### TUALATIN ARCHITECTURAL REVIEW BOARD SEPTEMBER 20, 2017, 6:30 PM POLICE TRAINING ROOM 8650 SW TUALATIN RD TUALATIN, OR 97062

The following conditions are highlighted as they could result in adjustments to the Site Plan, Sheet C1.1 (dated July 28, 2017):

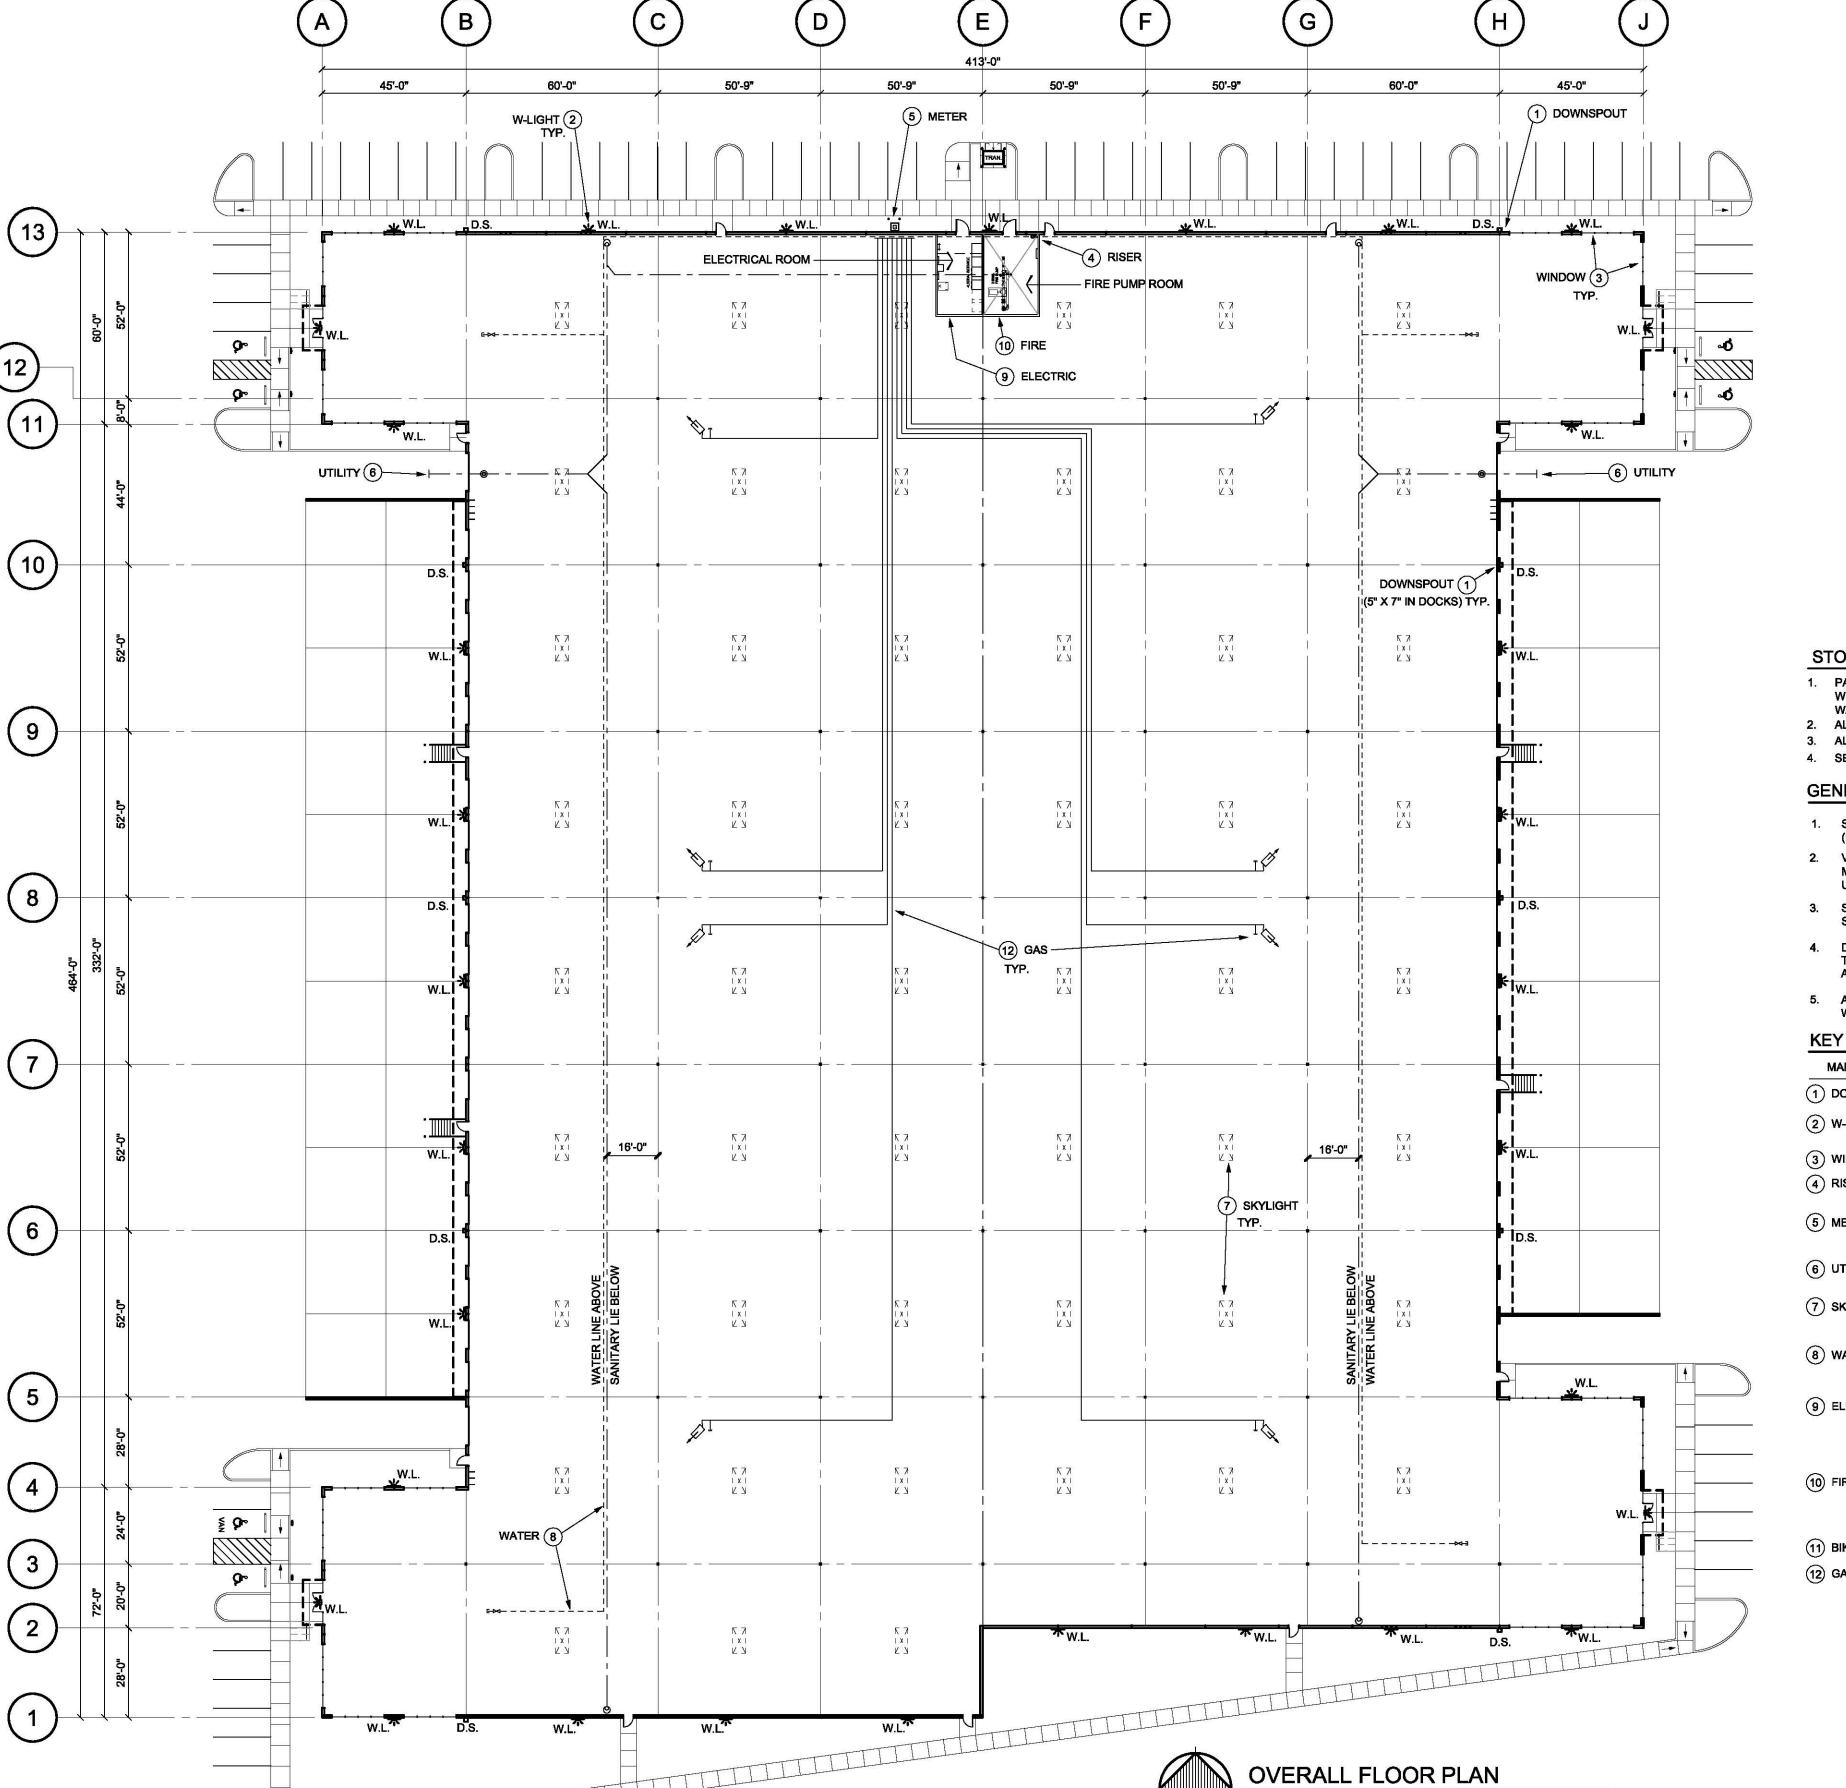
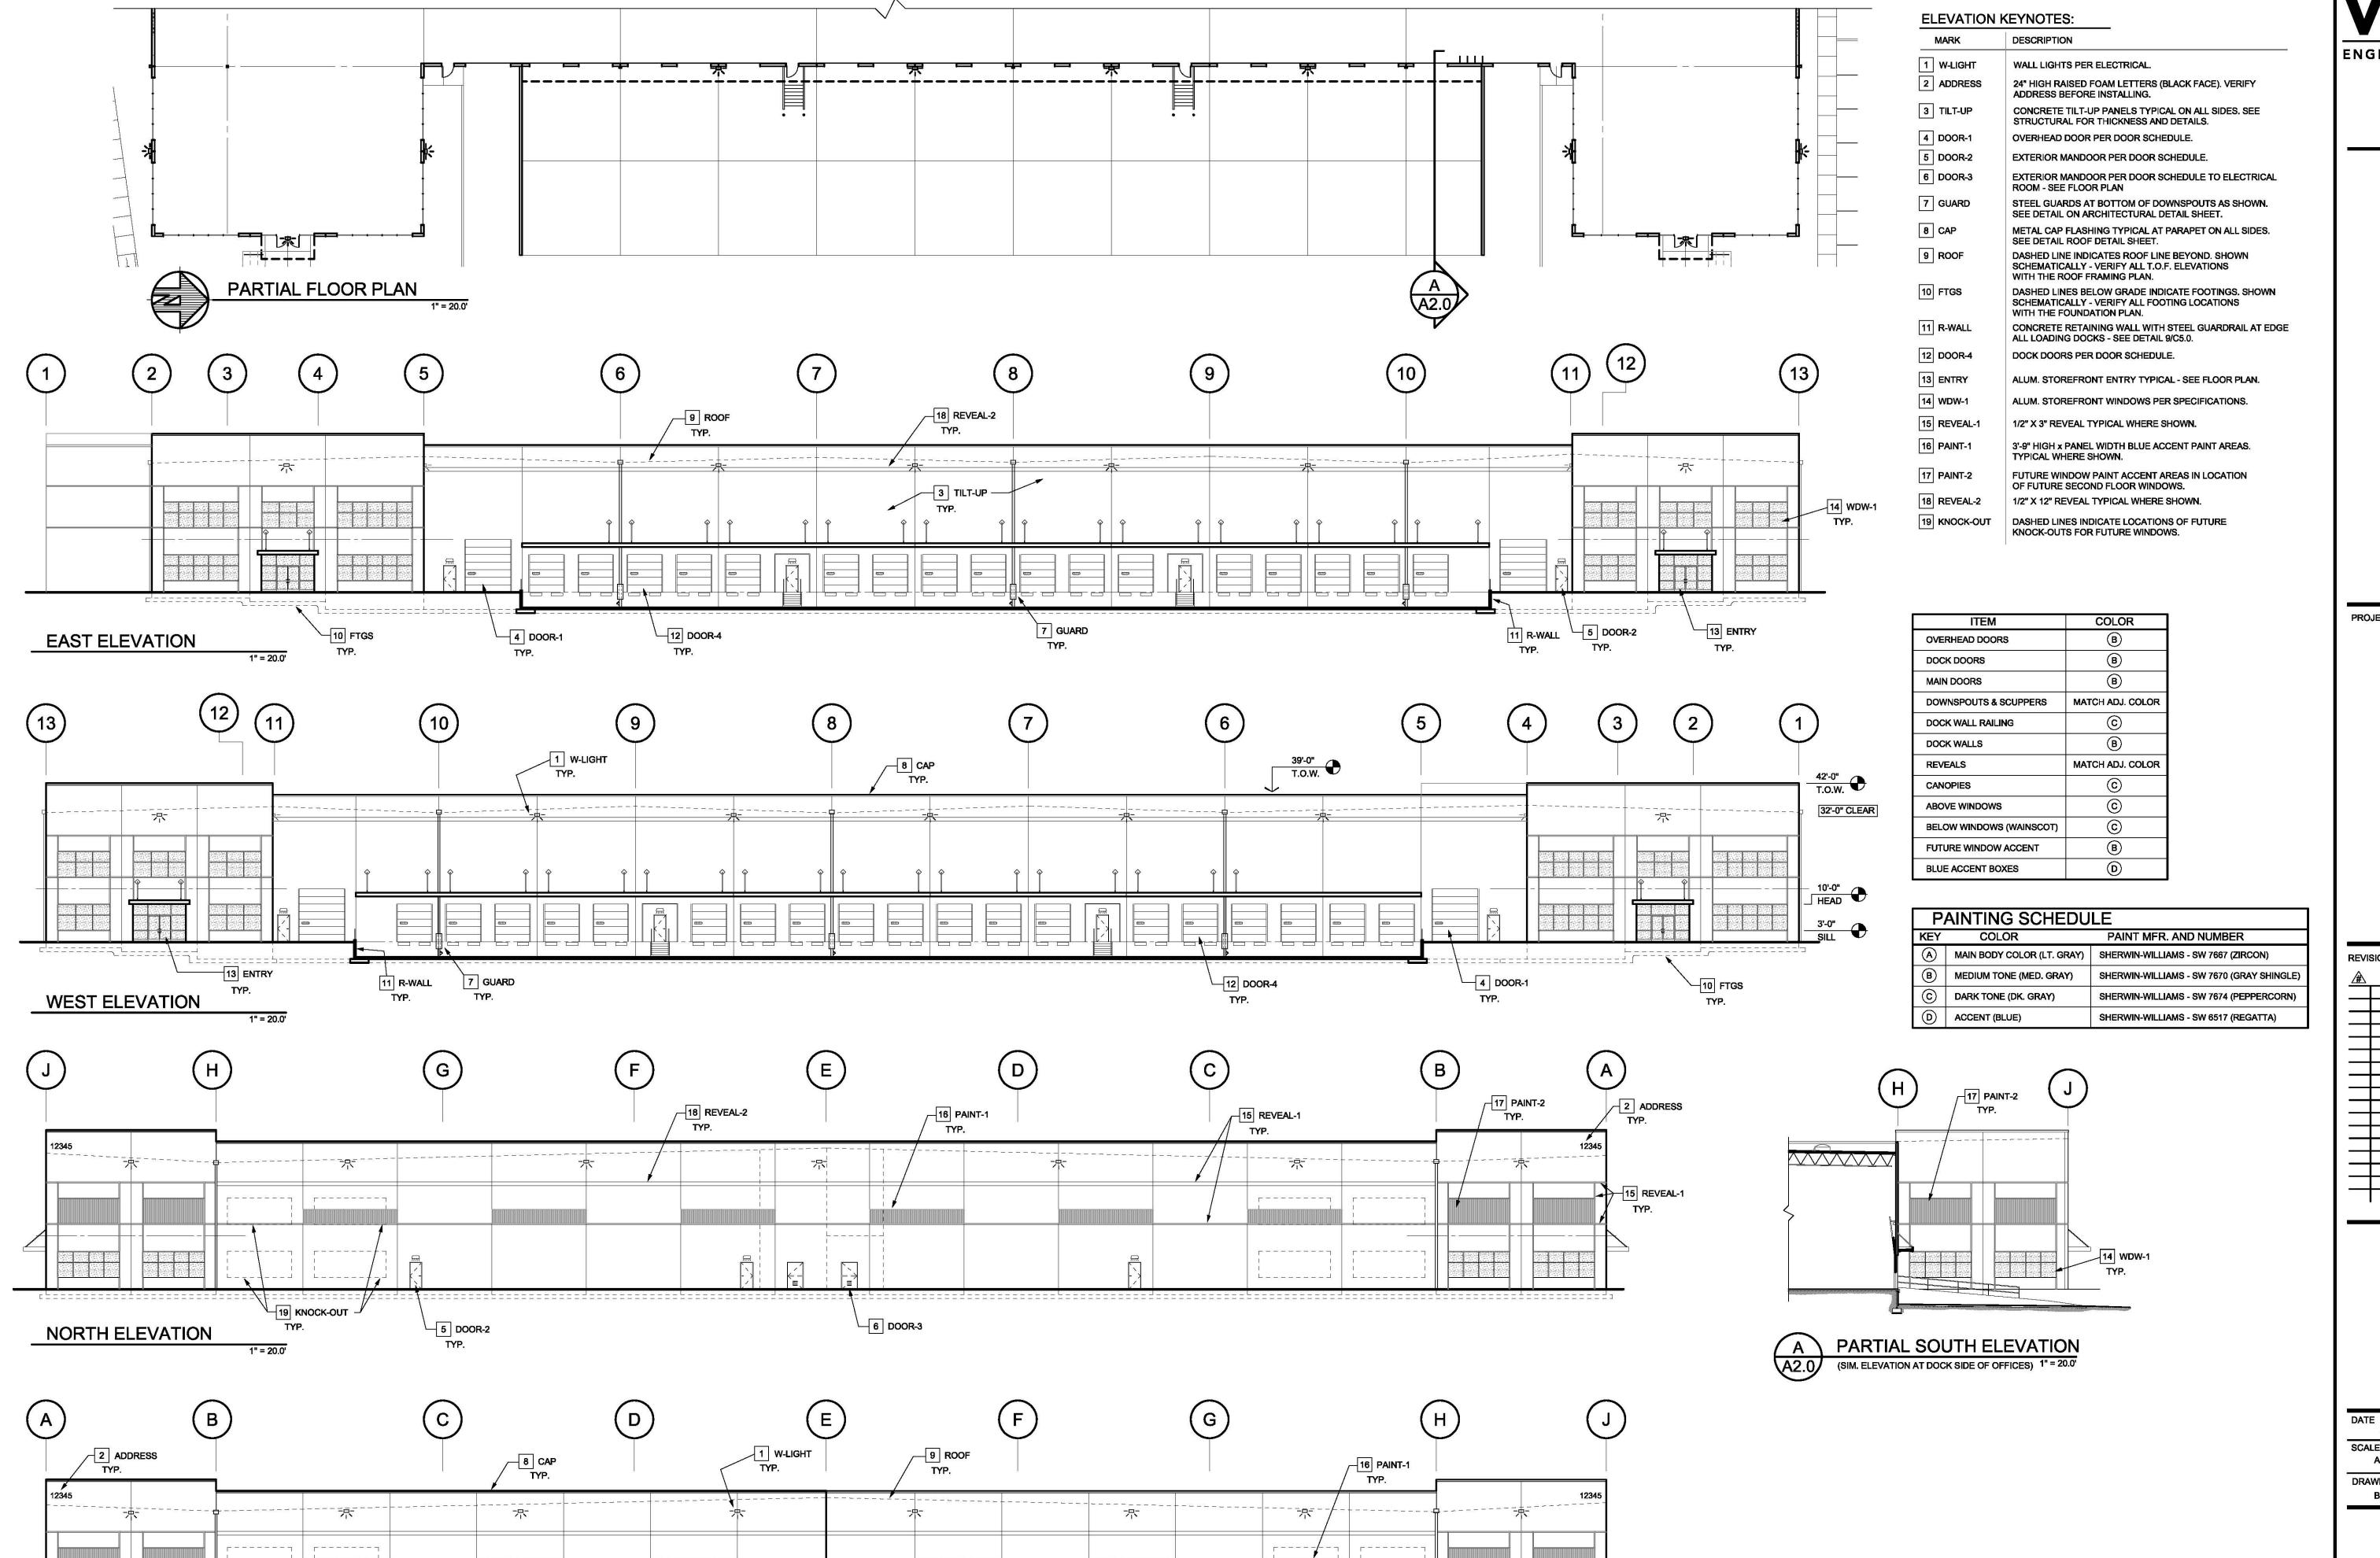
<u>Condition of Approval</u>: The applicant shall revise site plan (Sheet C1.1) to include building setback dimensions from property lines pursuant to TDC 61.060(1).

<u>Condition of Approval</u>: The applicant shall revise site plan (Sheet C1.1) to include building setback dimensions from property lines pursuant to TDC 61.060(2).

<u>Condition of Approval</u>: The applicant shall revise site plan (Sheet C1.1) to include parking and circulation area setback dimensions from public streets pursuant to TDC 61.060(5).

<u>Condition of Approval</u>: The applicant shall revise site plan (Sheet C1.1) to include landscape depth dimensions along both access driveways to/from SW Cimino Street pursuant to TDC 73.360(6)(a).

<u>Condition of Approval:</u> Revise the site plan (Sheet C1.1) and the overall development plan to include the minimum amount of required bicycle parking pursuant to TDC 73.370(2)(a).

Staff finds that this standard is not met. Per the table above, the proposed 155 parking spaces would require seven (7) vanpool/carpool spaces; Sheet C1.1 Site Plan (dated July 28, 2017) only illustrates six (6) vanpool/carpool spaces.

<u>Condition of Approval:</u> The applicant shall revise the site plan (Sheet C1.1) to include the minimum number of required vanpool/carpool parking spaces pursuant to TDC 73.370(3).

<u>Condition of Approval</u>: The applicant shall revise site plan (Sheet C1.1) to include loading dock/berth dimensions pursuant to TDC 73.390(2).
